ST. TAMMANY PARISH

Addendum No.: 3

Bid#: 25-38-2

Project Name: Tammany Trace Bridge #25

Section 18

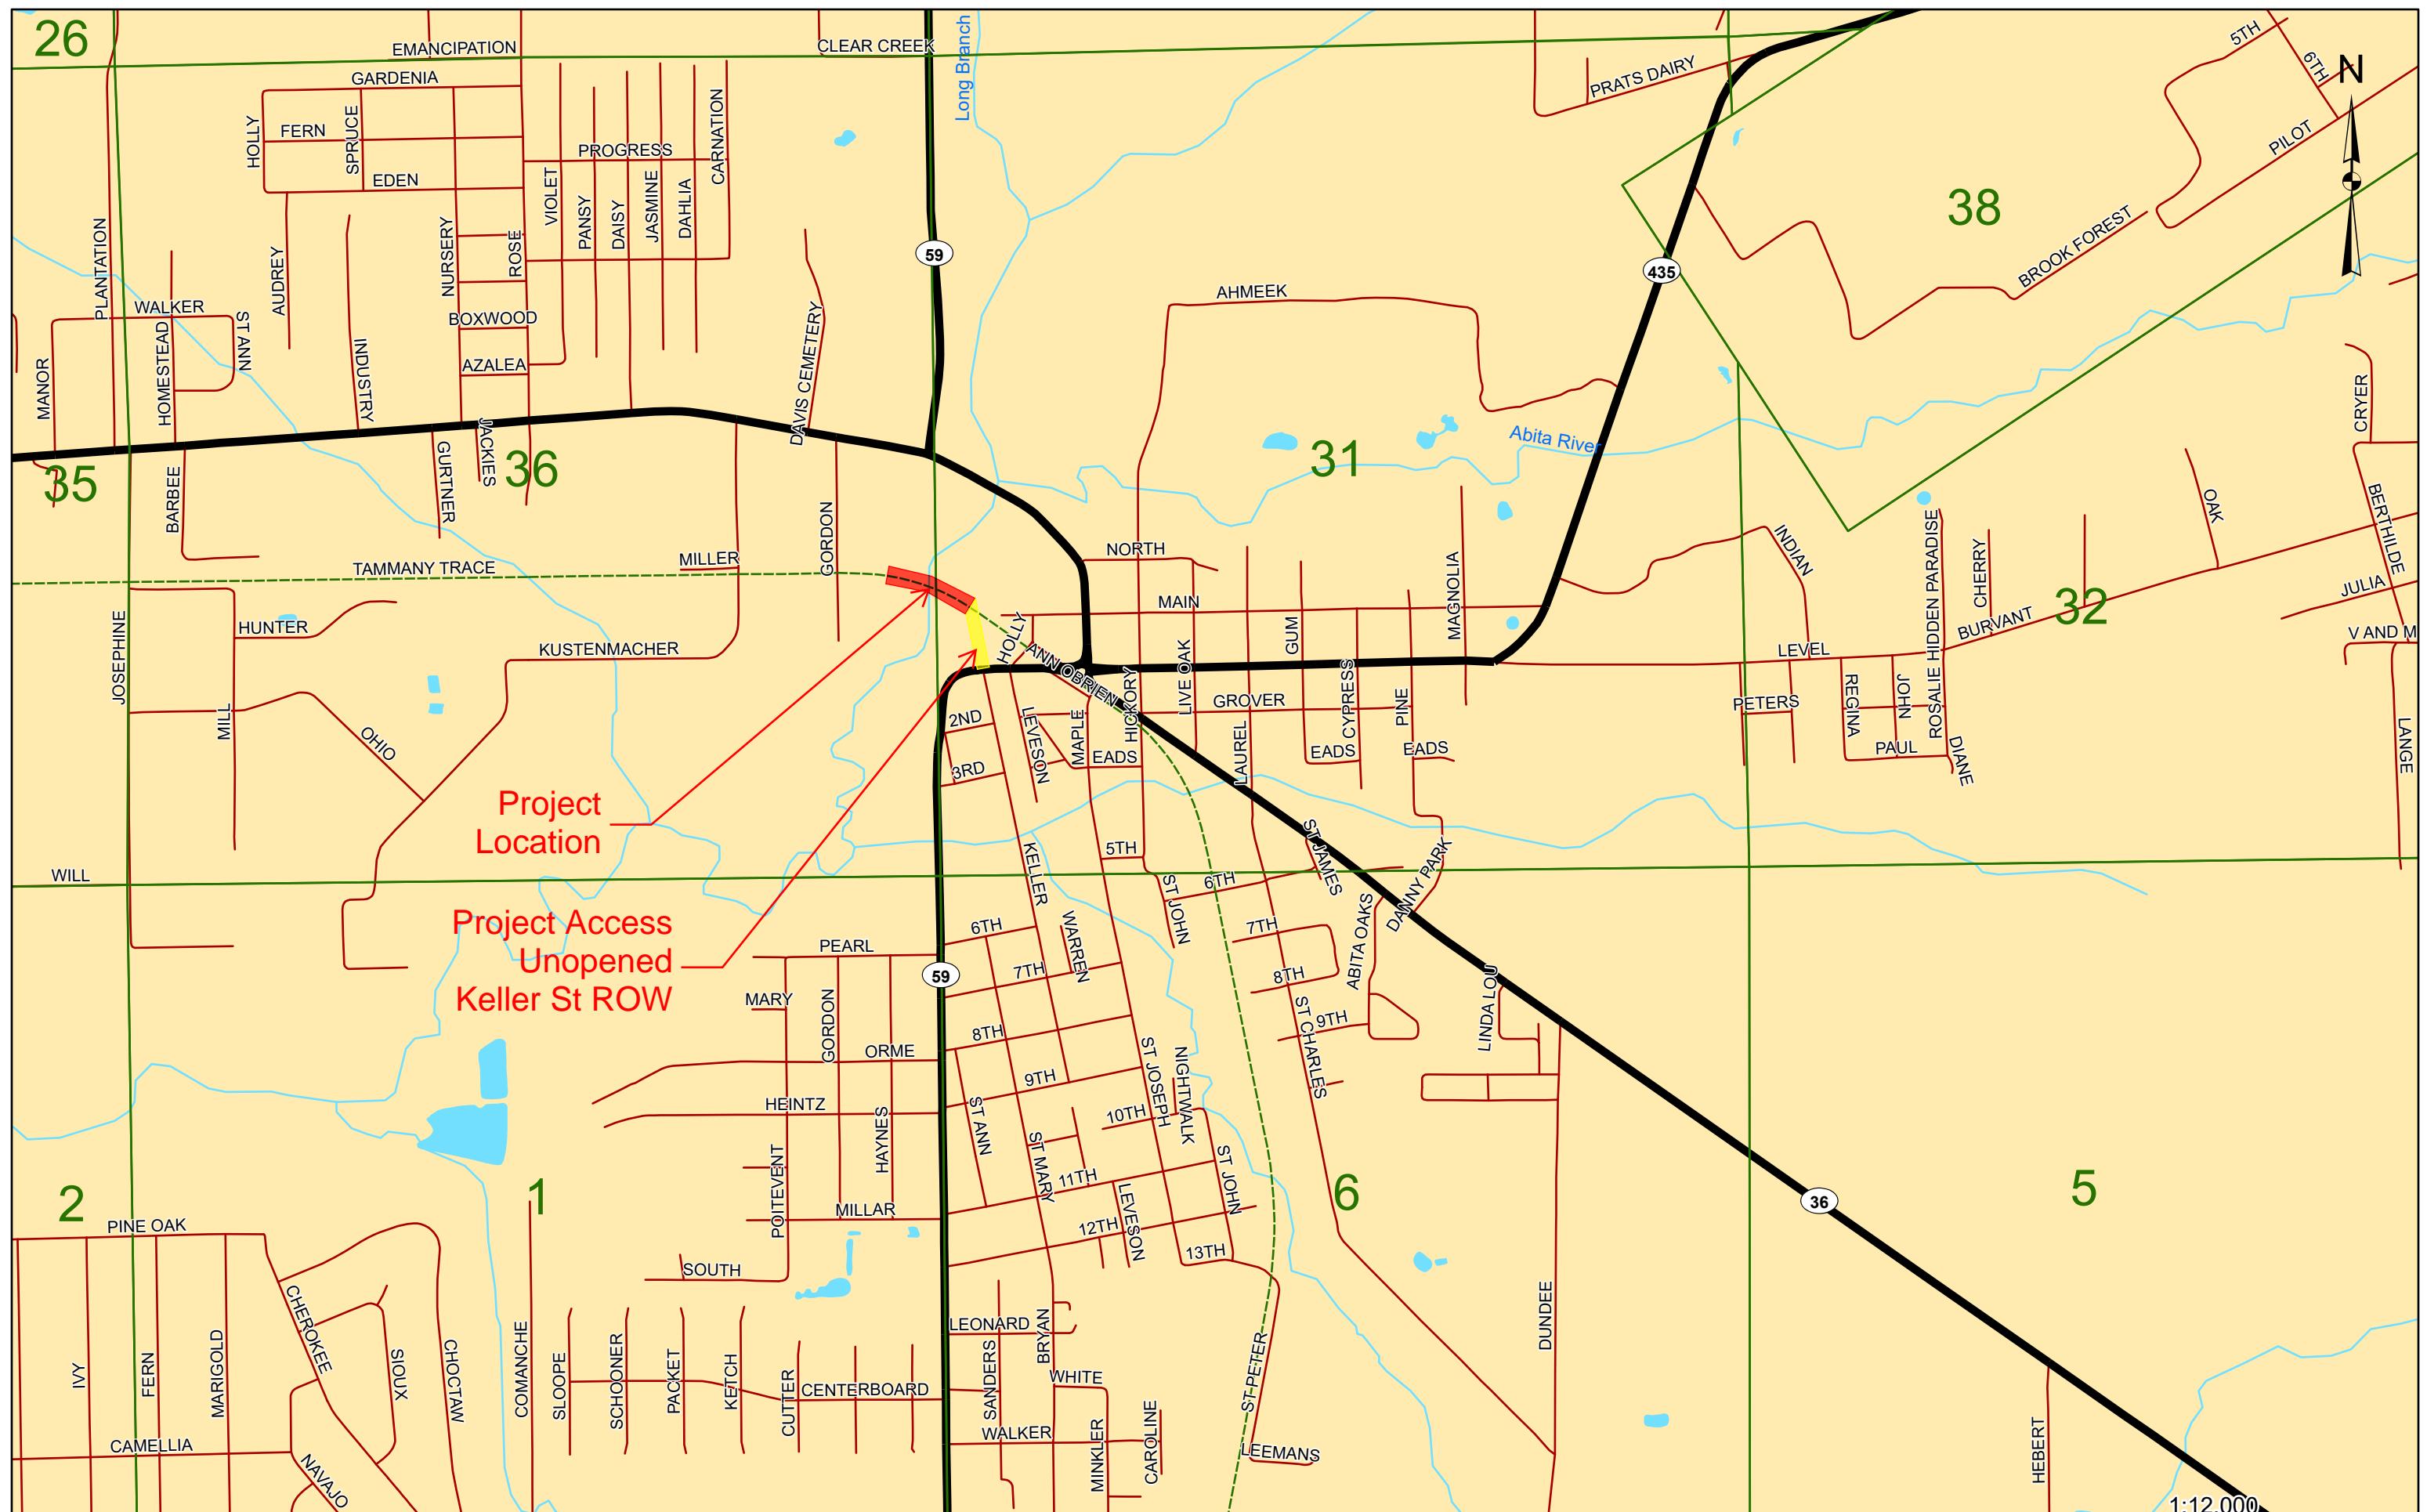
Question 4. What is the preferred route for contractor to access site? Project will require earthmoving equipment and crane to install bridge. Crane mobilization will require construction of haul road. Will the contractor be allowed to access site through Main Street / Park Area?

Question 24. Will the contractor have access though the park to bring equipment and the bridge sections in ?

Answer 4. Contractors will have access from both sides of the bridge via the Tammany Trace, as well as the unopened Keller St right-of-way. Contractor will be responsible for any clearing required to use the Keller St right-of-way. Please refer to General Information #1, Section 18 - Right-of-Way Map (attached).

Answer 24. Contractors will have access from both sides of the bridge via the Tammany Trace, as well as the unopened Keller St right-of-way. Contractor will be responsible for any clearing required to use the Keller St right-of-way. Please refer to General Information #1, Section 18 - Right-of-Way Map (attached).

Section 20

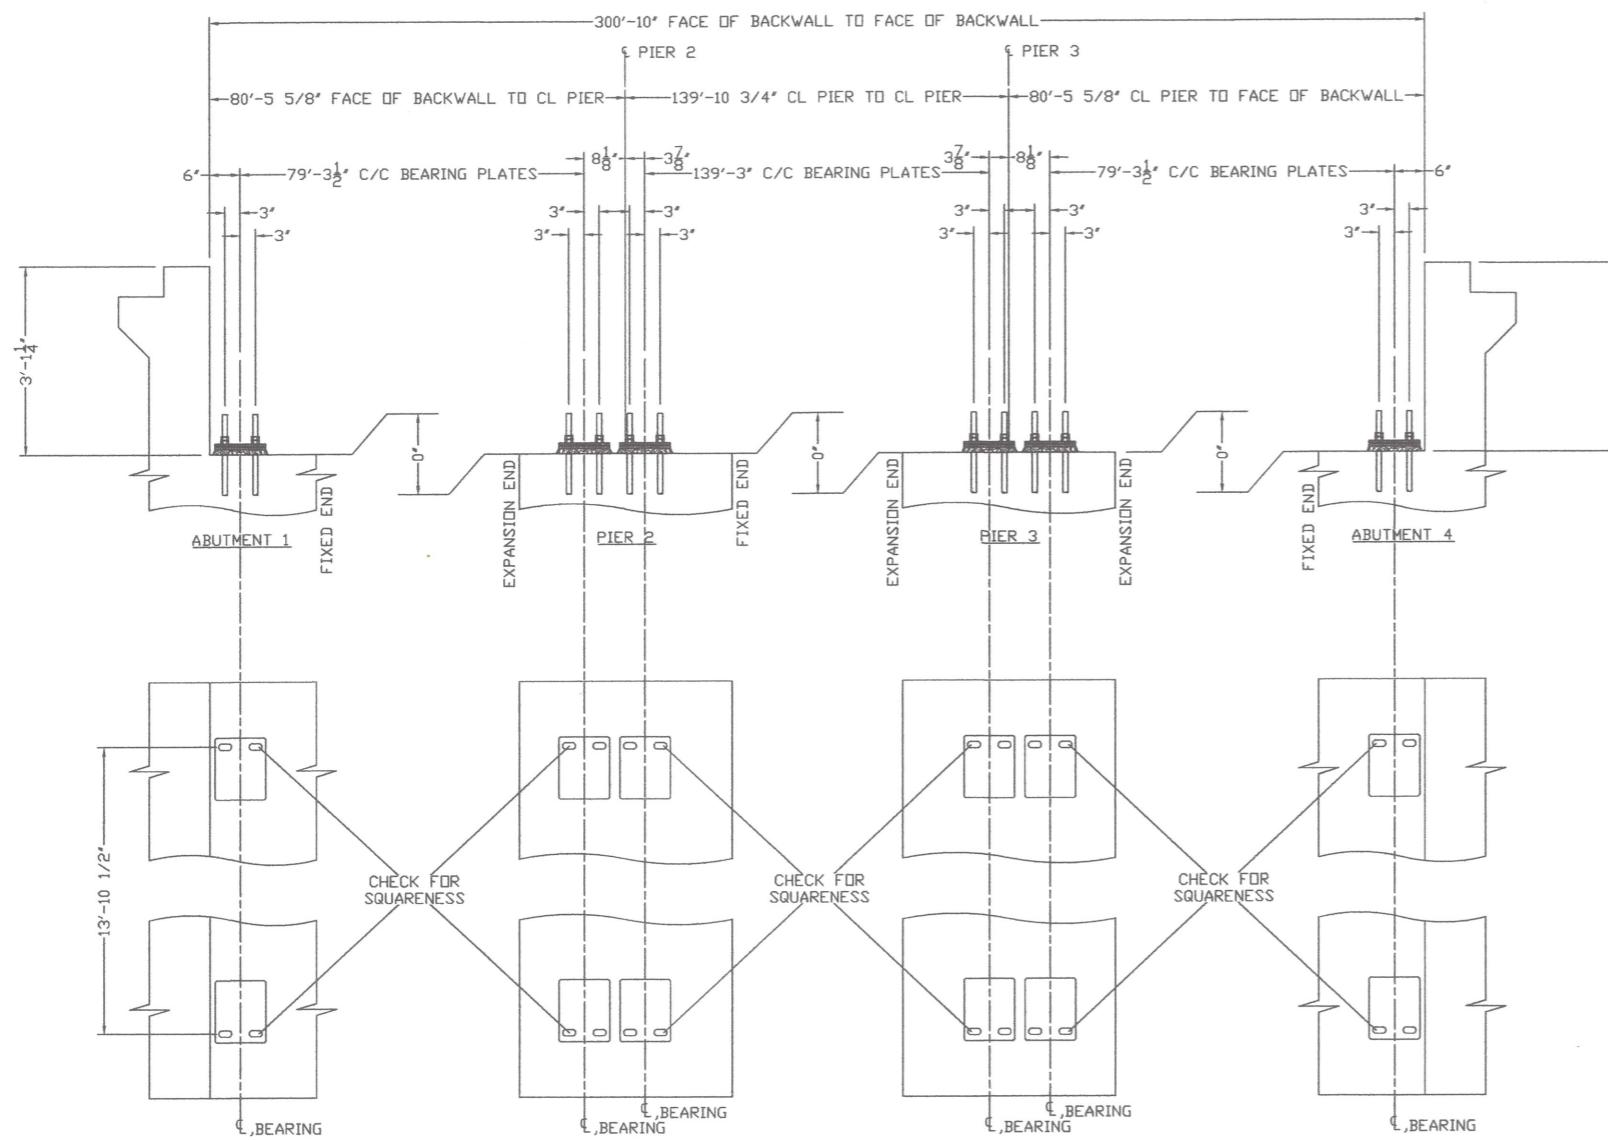
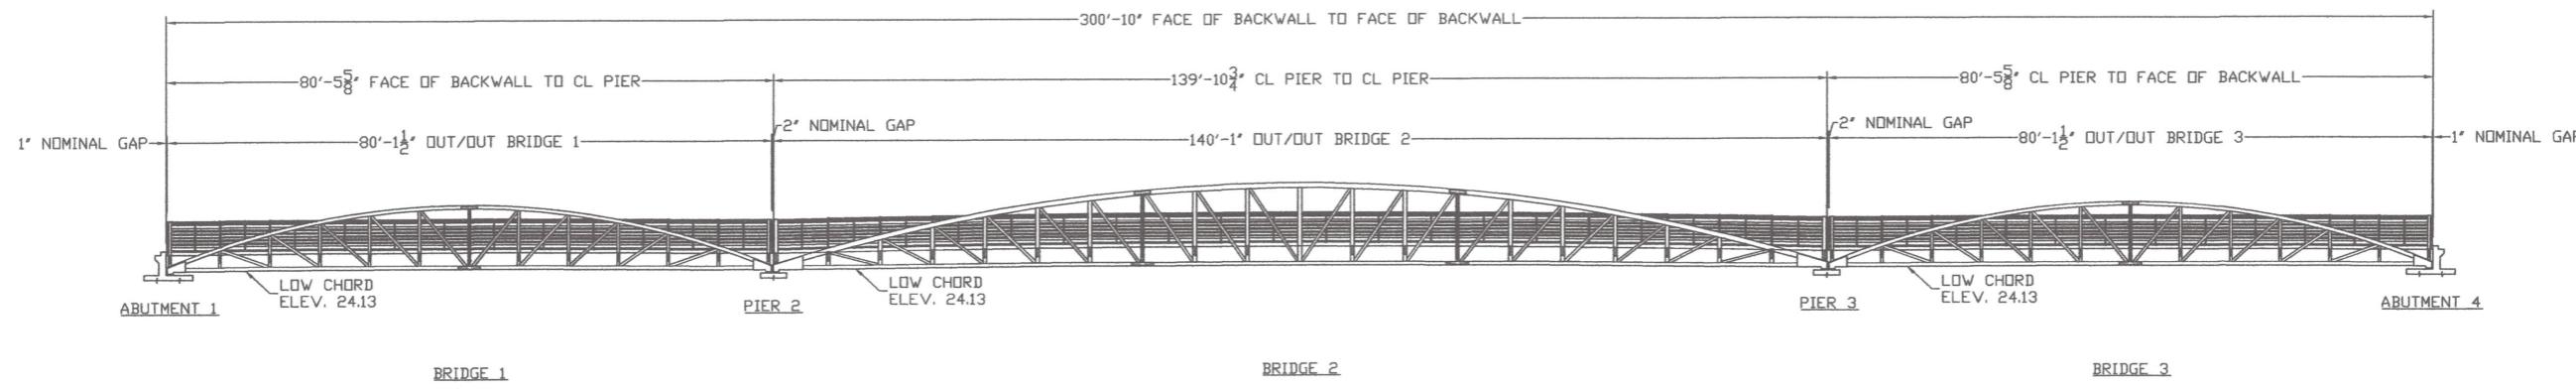
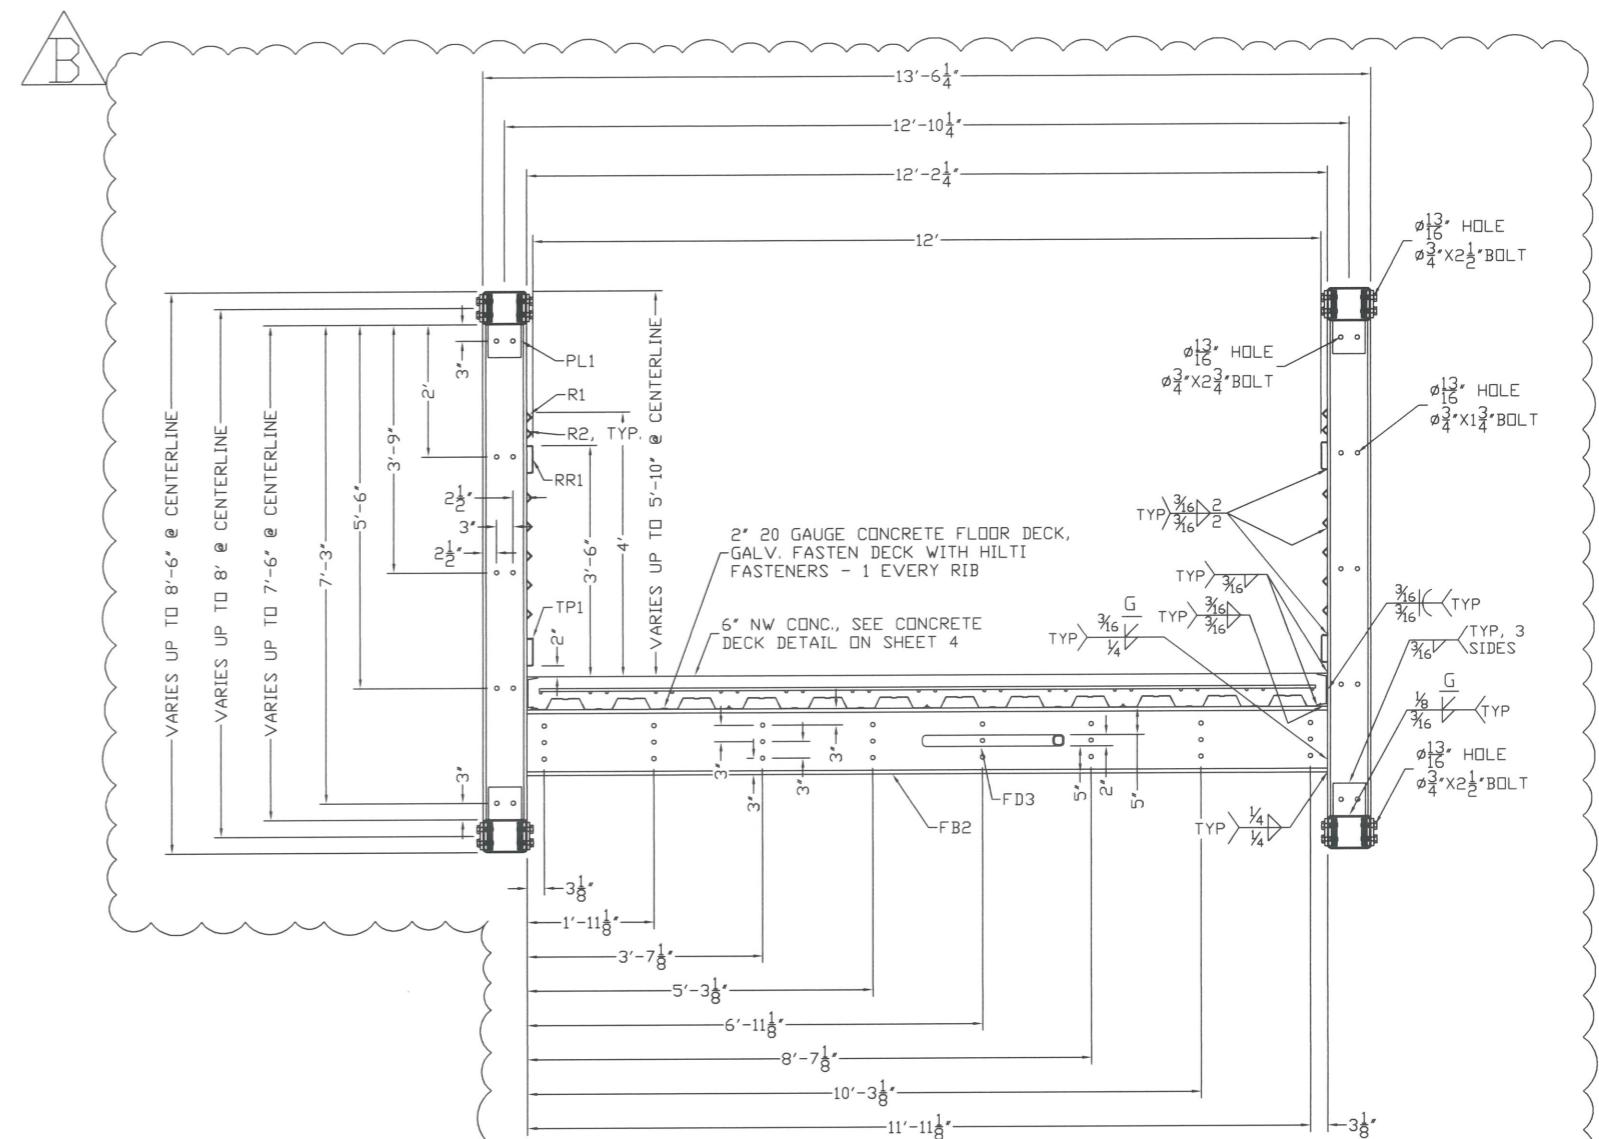
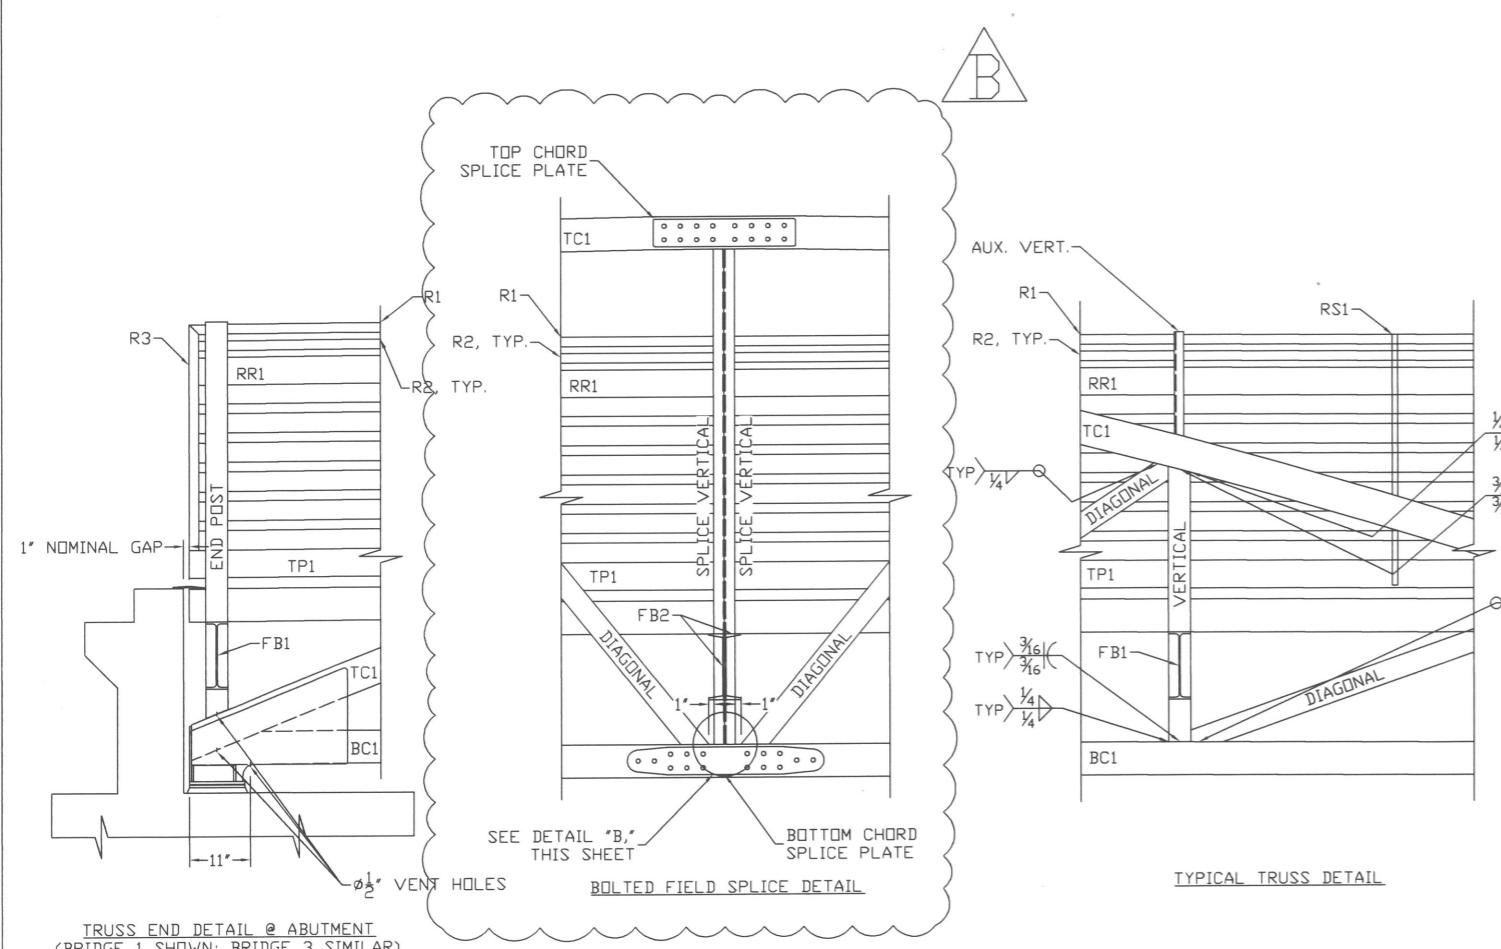
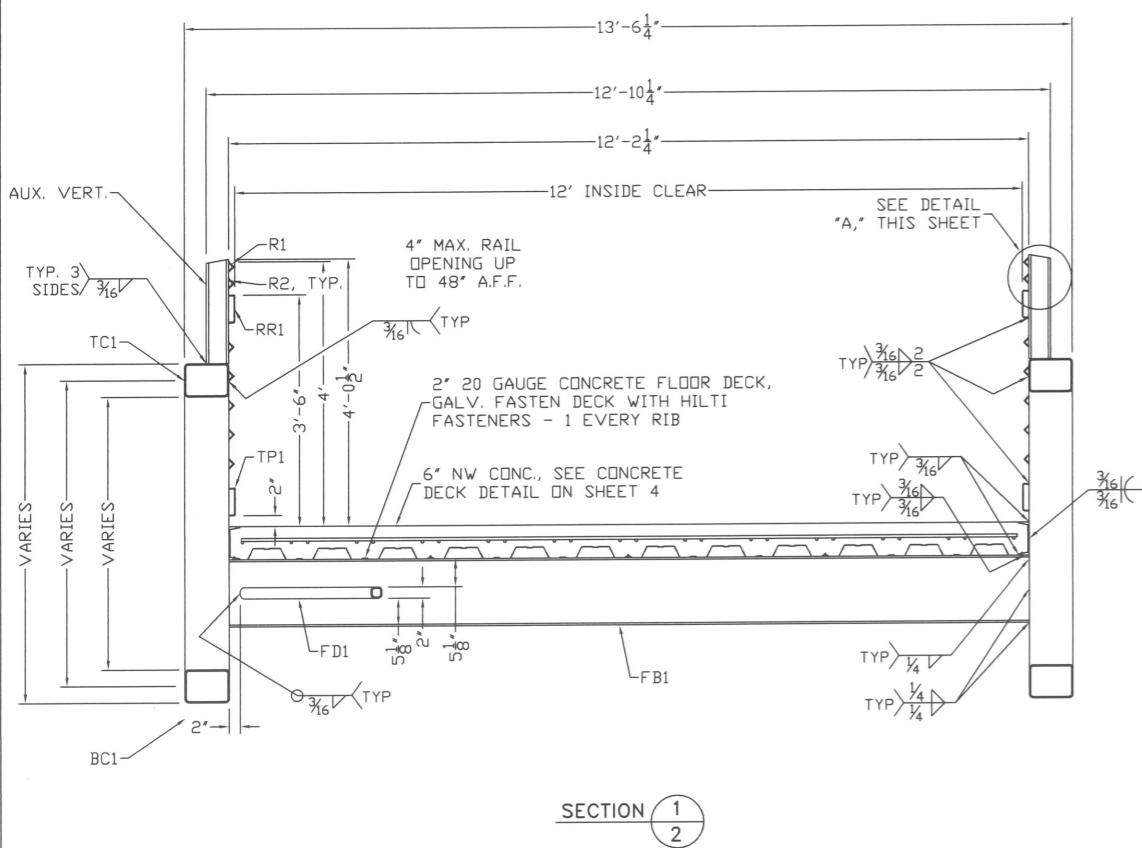
Question 8. Please provide a plan or detail for the concrete deck to be installed.

Question 14. Please provide shop drawings of the new owner furnished bridge units so we will know how much assembly is required.

Question 19. Will the owner furnish bridge come with permanent metal deck forms?

Question 20. Will the owner furnish bridge come with bearing pads?

Answer 8. Please refer to General Information #1, Section 20 – Shop Drawings.

Answer 14. Please refer to General Information #1, Section 20 – Shop Drawings.

Answer 19. Please refer to General Information #1, Section 20 – Shop Drawings.

Answer 20. Please refer to General Information #1, Section 20 – Shop Drawings.
